SUBJECT: Forwards response to NRC 980626 RAI re analysis to evaluate effects of one svc water pump available - post-LOCA.

Subject: Response to Request for Additional Information (RAI) Related to the Effects of
One Service Water Pump Available - Post-Loss-of-Coolant Accident (TAC No.
M84947)
R. E. Ginna Nuclear Power Plant
Docket No. 50-244

RG&E RESPONSE TO NRC 6-26-98 RAI

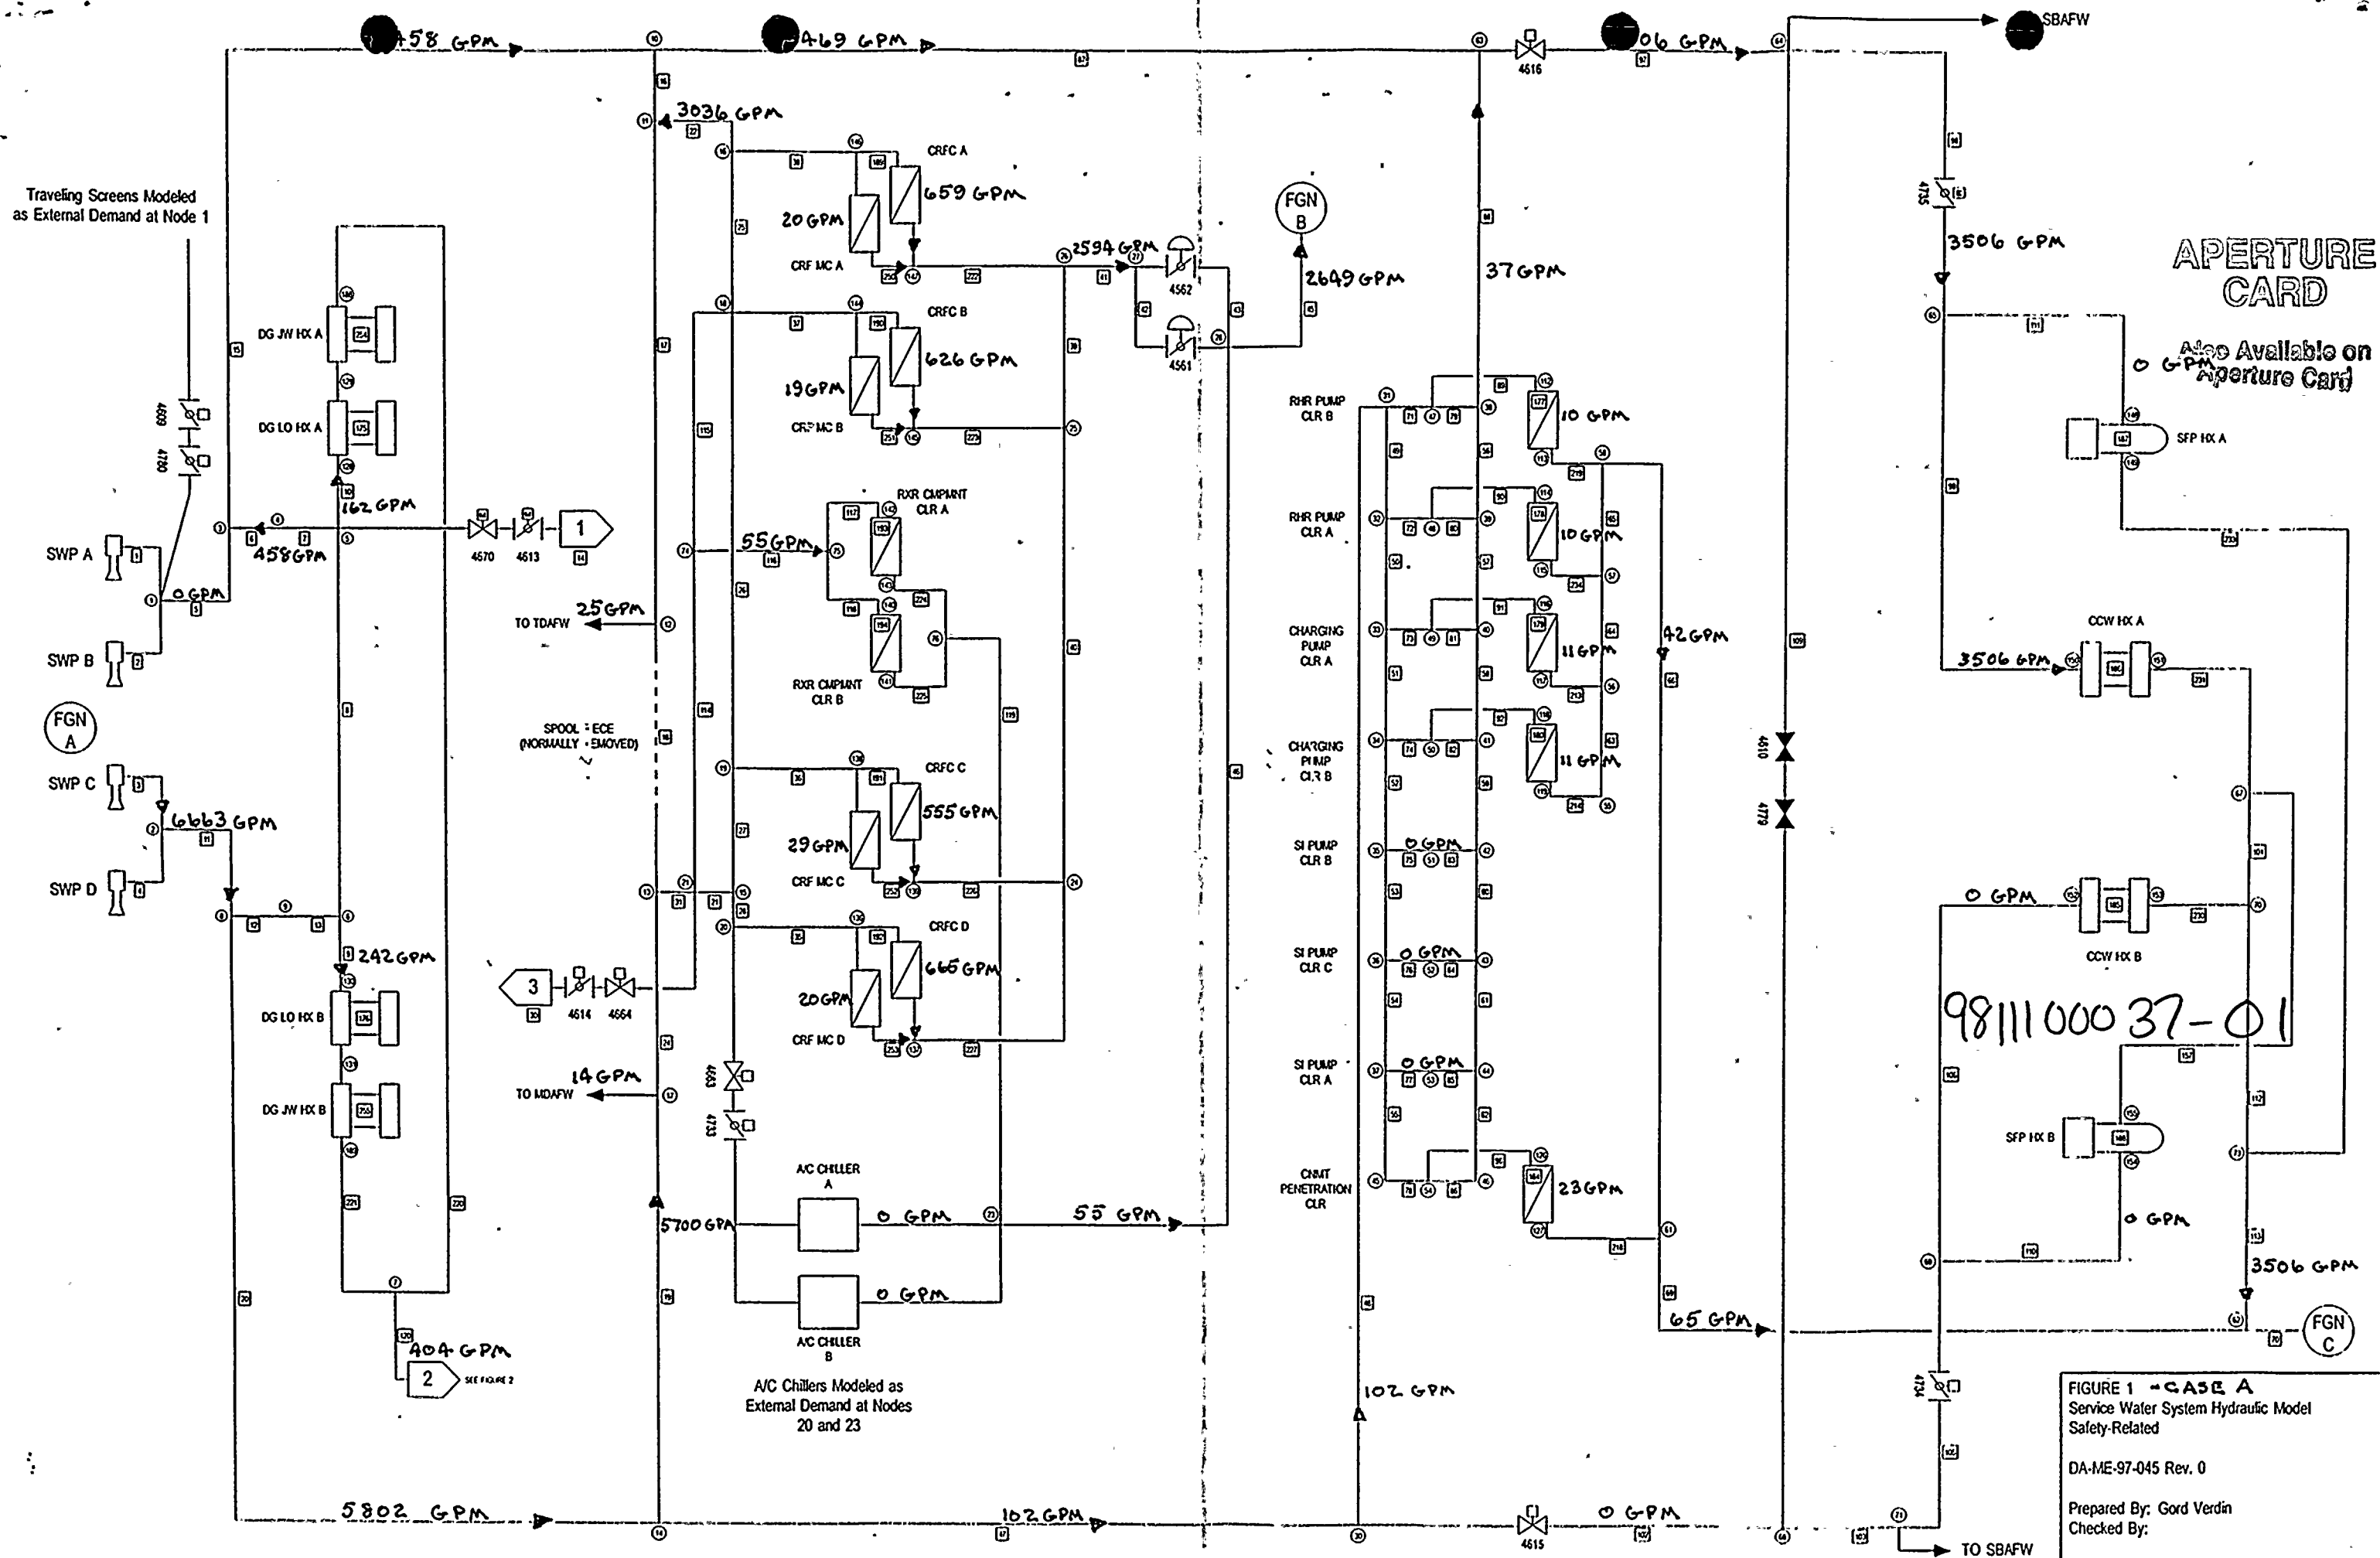
The bounding maximum flow case for single service water (SW) pump operation has not been clearly defined. What is the maximum flow case for one SW pump?

Case A evaluates the design basis LOCA condition assuming that only one SW Pump instead of the two assumed by the UFSAR is available during the Recirculation Phase of a LOCA. Since the non-safety related SW loads have been isolated by the SI actuation, this case does not represent a bounding condition for maximum SW Pump flow. However, this case results in less long term cooling of containment due to the reduction in SW flow to the Containment Recirculating Fan Coolers (CRFCs) and the Component Cooling Water (CCW) Heat Exchangers in the Recirculation Phase. The flows to these components are below their nominal design flows which results in reduced heat rejection to the Ginna ultimate heat sink during the Recirculation Phase of the LOCA. Additionally, reduced SW flow to the Emergency Diesel Generators (EDGs) also occurs for this scenario. Consequently, the major concerns related to this scenario are long term containment cooling capability and EDG cooling.

Additionally, for conservatism the SW piping hydraulic resistance was based upon pipe roughness for piping exposed to water conditions for forty years. The minimum expected lake level along with the minimum SW Pump performance allowed by the ISI program for pump operability have been used to minimize flow to the functioning safety related components. A maximum lake temperature of 85°F is also assumed in the hydraulic model consistent with the lake temperature used for assessing long term containment cooling and EDG cooling capability. This minimizes the SW cooling capability for cooling both containment and the EDGs. The SW configuration assumed for the LOCA recirculation phase is consistent with the present instructions specified in Emergency Procedure ES-1.3 (Reference 1) for one available SW Pump during transfer to Cold Leg Recirculation. Consequently, SW flow is only re-established to one CCW Heat Exchanger. Additionally, all LOCA non-essential loads are manually isolated by Operations as explained in the Question 6 response. The SW flow distribution calculated by KYPIPE for this scenario (Reference 12) are summarized on Figure 1.

To demonstrate that sufficient cooling is provided, RG&E used the SW flow results shown on Figure 1 for the LOCA Recirculation Phase to quantify the heat removal capability of the CRFCs and the one operating CCW Heat Exchanger. Using these heat removal characteristics, the design basis LOCA was re-analyzed (Reference 15) to assess the impact of reduced SW flow on the containment long term transient pressure and temperature profile. The resulting containment profile was then compared to the Ginna containment EQ profile. This comparison which is shown in Figure 3 demonstrates that the EQ pressure and temperature profiles are not exceeded following the LOCA. Consequently, although reduced SW flows lengthens the time required to cooldown and de-pressurize containment, adequate long term containment cooldown and de-pressurization is still provided.

For the EDGs during the LOCA Recirculation Phase, Figure 1 indicates that the minimum SW flow to the EDGs is 162 gpm. This is below the EDG design SW flow of 320 gpm listed in UFSAR Table 9.2-2. However, as shown in UFSAR Table 8.3-2 the maximum EDG loading during the LOCA Recirculation Phase is approximately 16 % below the EDG design rating (1631 kw vs 1950 kw). If only one SW Pump was available during the Recirculation Phase of a LOCA, the Table 8.3-2 loading would be reduced by another 243 kw due to having only one SW Pump loaded on the EDG. Consequently, the actual EDG loading for a one SW Pump case would be 1388 kw or approximately 28 % below the EDG design rating.

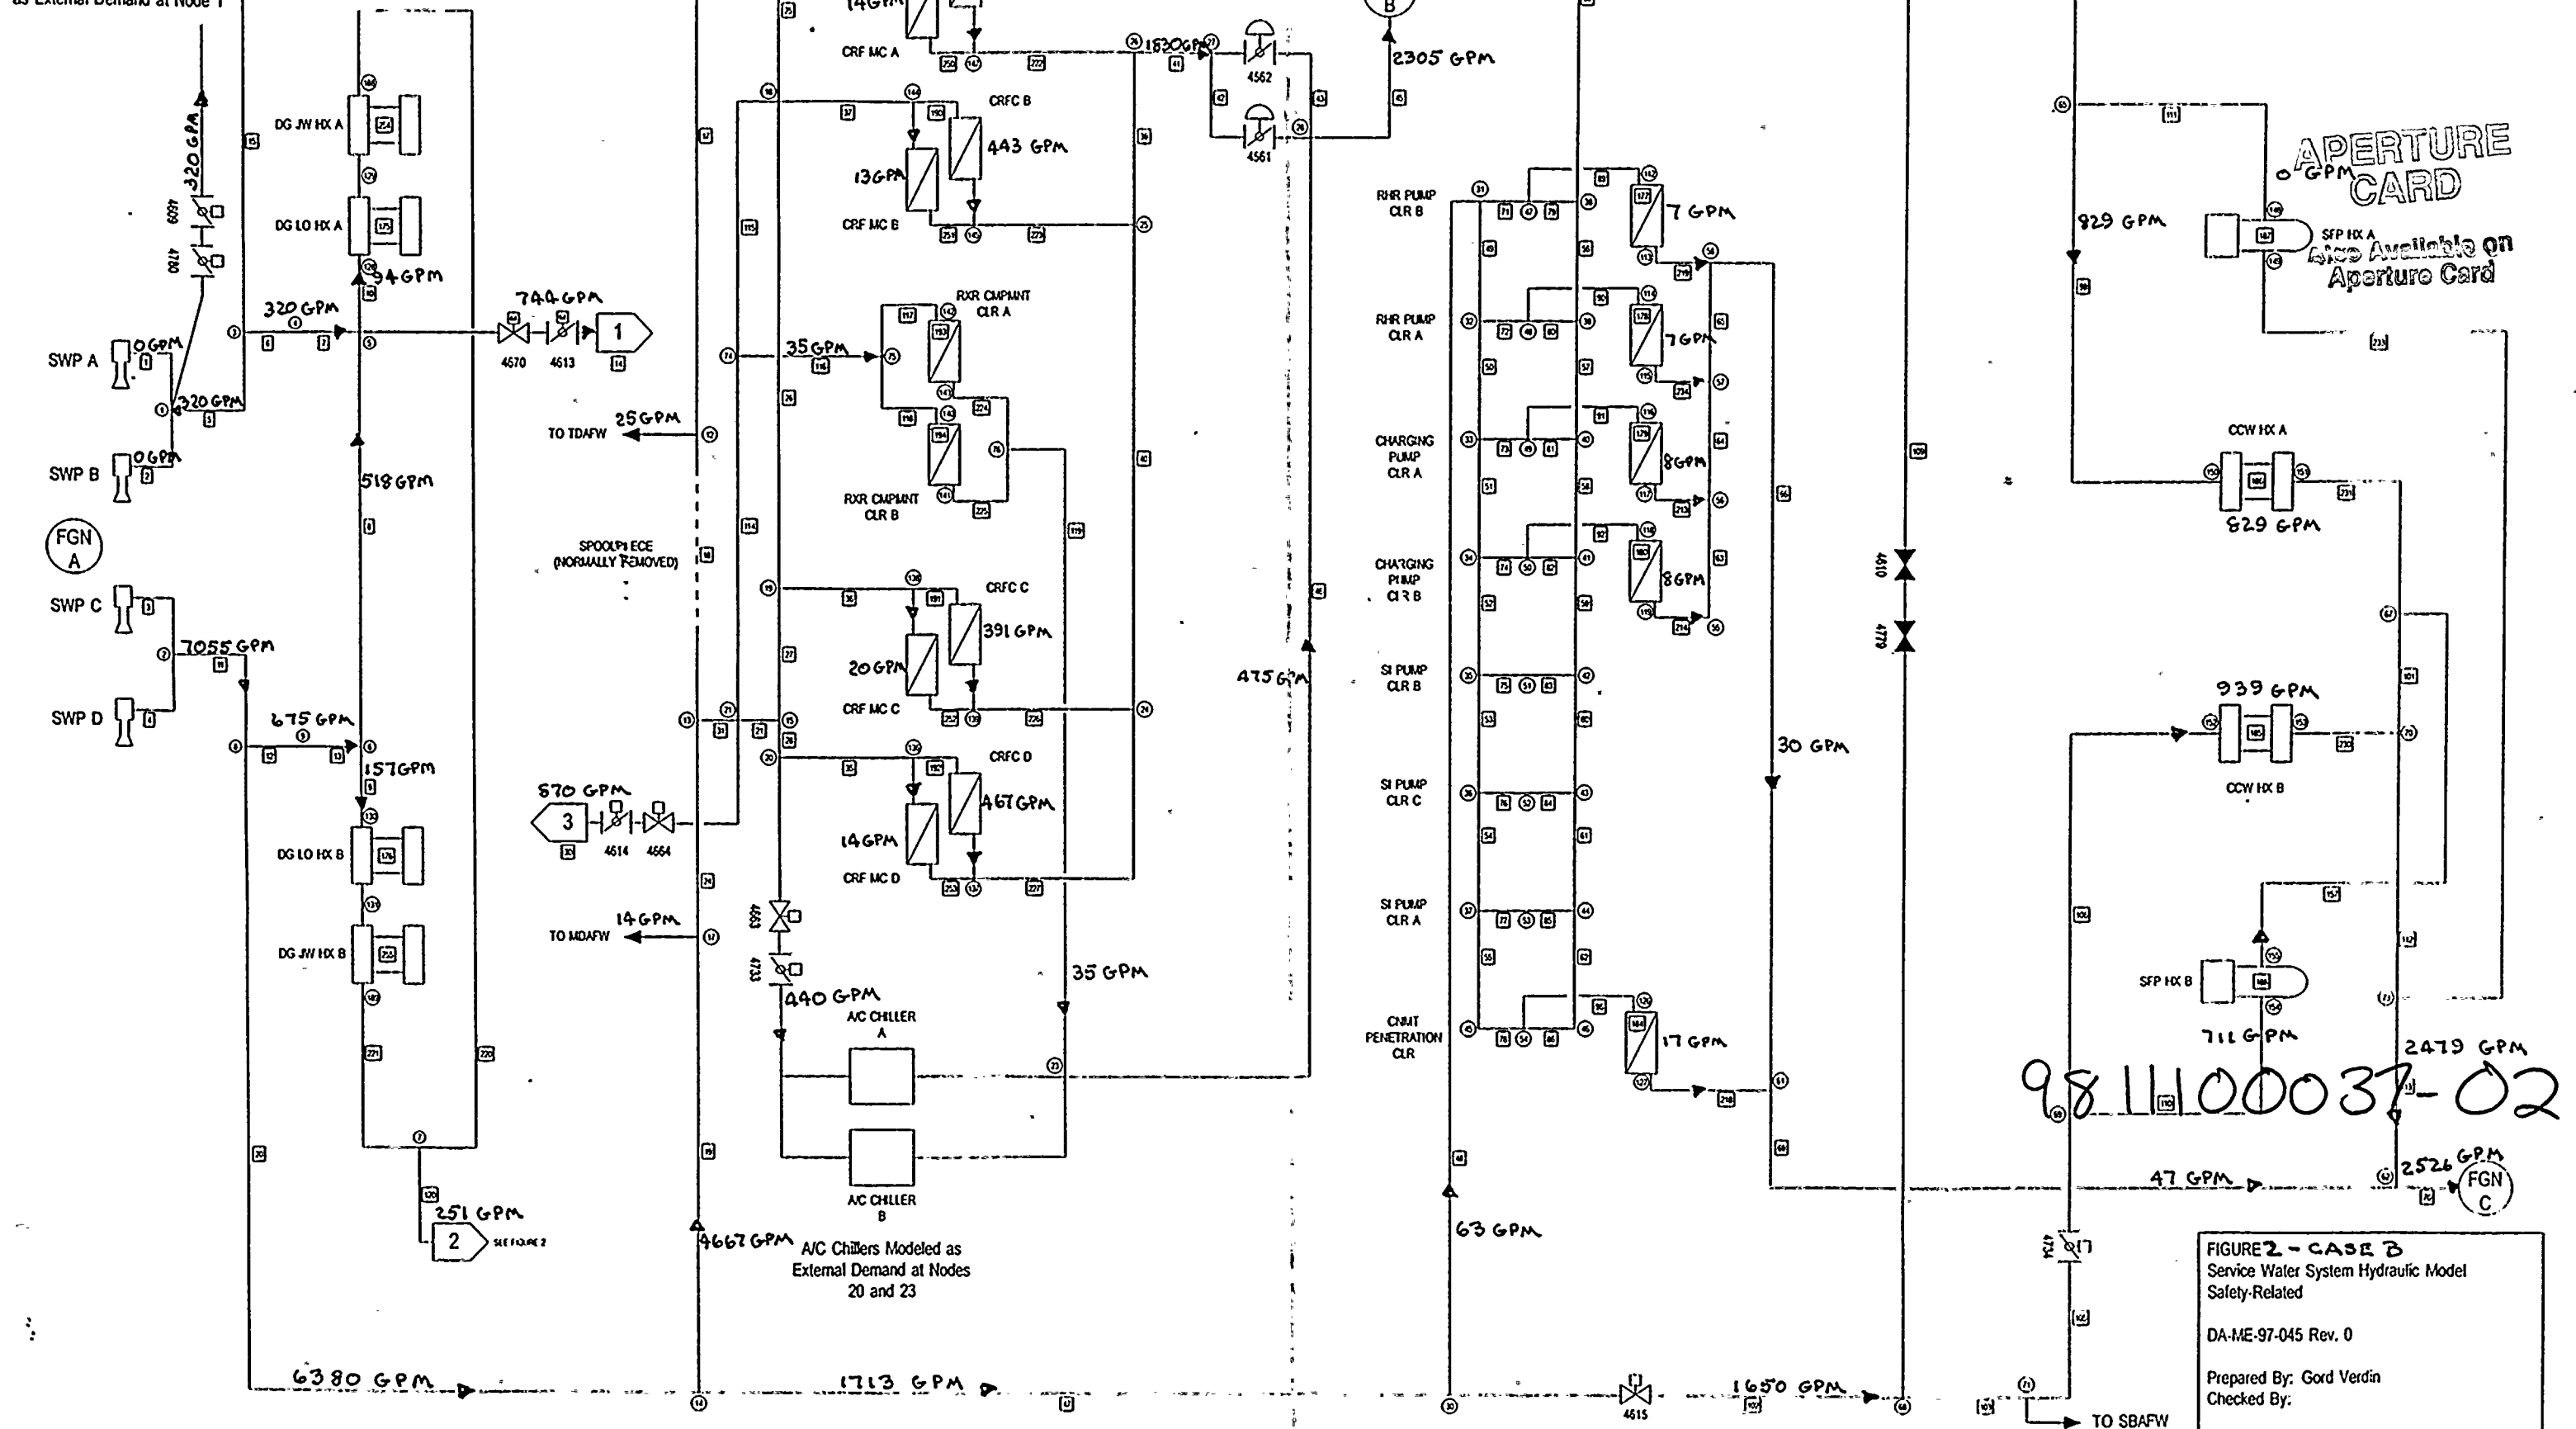
The Case B scenario results in the maximum SW Pump flow which needs to be evaluated for its effect on pump operability. The purpose of this limiting case is to ensure that the SW Pump is not damaged prior to manual actions to isolate non-essential SW loads. Also, since this is a non-LOCA scenario with LOOP, the adequacy of SW cooling to the EDGs is also evaluated. Due to Case B being a non-LOCA scenario, the corresponding EDG loading for assessing SW cooling adequacy is appreciably lower than the EDG LOCA design basis loading.

Since this scenario involves a failure of a SW Pump following a reactor with a LOOP condition and without a concurrent SI actuation, the non-safety related SW loads are not automatically isolated for this case. The availability of the non-safety related SW flow paths results in a significantly reduced SW hydraulic resistance when compared to the Case A configuration. To minimize available flow to the EDGs, the overall SW system hydraulic resistance prior to the LOOP is conservatively based upon assuming a three SW pump normal operating condition prior to the LOOP initiating event. This is representative of summer operating conditions where the minimum overall hydraulic resistance of the SW System would exist. Consequently, the limiting single active failure for this one SW Pump scenario would be the failure of the one EDG associated with two of the three normally operating SW Pumps. This assumption maximizes the SW flow to the non-safety related portions of the SW System thereby minimizing the available SW flow to an operating EDG. The SW flow distribution calculated by KYPIPE for this scenario (Reference 12) for evaluating functionality of the EDGs is summarized on Figure 2.

Figure 2, the minimum SW flow to the EDGs is approximately 94 gpm which is below the EDG Lube Oil and Jacket Water Cooler design flow of 320 gpm. However, for this condition the actual load on the EDG is also below the EDG continuous operating design loading of 1950 kw. The only major components that would be required to be continuously loaded on a functional EDG immediately following a LOOP condition to maintain the plant in a Hot Shutdown condition (e.g. RCS at HZP conditions) are:

Due to the reduced loading on the EDG, the actual heat load rejected to the Lube Oil and Jacket Water Coolers is well below the design loading for these coolers. Based upon the expected EDG load and information from the EDG vendor relating EDG heat rejection to EDG loading, an analysis was performed to quantify the maximum expected lubricating oil and jacket water inlet temperatures based upon a SW flow of 94 gpm and maximum expected SW inlet temperature. The analysis also assumed that the EDG coolers were operating at their maximum allowed plugging and fouling conditions. This analysis (Reference 14) has determined that both the Lube Oil and Jacket Water Cooler inlet temperatures are below the EDG manufacturer's values of maximum allowed operating temperatures. Consequently, the reduced SW flow available to the EDGs for this scenario provides adequate cooling for continuous operation with the expected EDG loading. Additionally, as noted in Question 1d above, since isolation of non-essential SW loads would be accomplished in a short time period following the LOOP and EDG start-up, SW flow to the EDG would be restored to a value close to its design flow.
